## Product/Process Change Notice (PCN)

PCN #: WE\_LQ\_20160920

Product Affected: WE-LQ size 1812 series

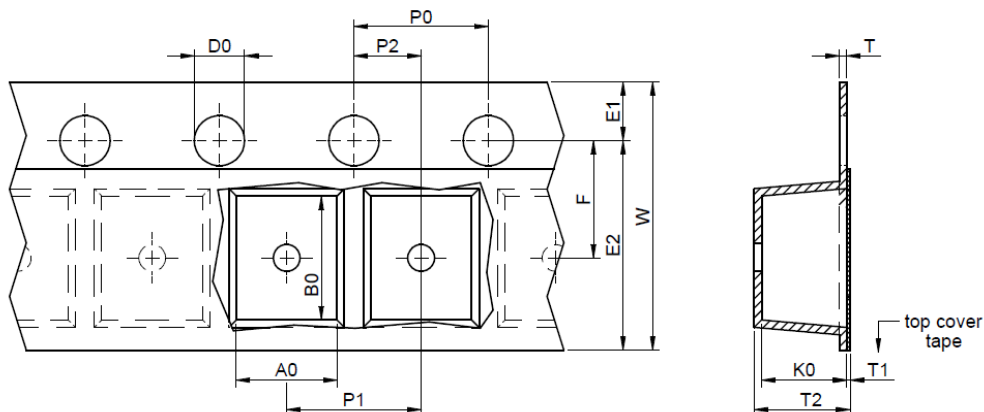
In order to improve the quality of transportation, the cavity of the carrier tape will be changed to reduce the movements and avoid wrong positions in the carrier tape.

The dimension B0 and T2 will be change from 5.00 mm and 3.50 mm, respectively, to 4.80 mm and 3.35 mm, reducing the space at the case where the parts are located into the carrier tape.

Dimension	Before Change	After Change
B0	5.00	4.80
T2	3.50	3.35
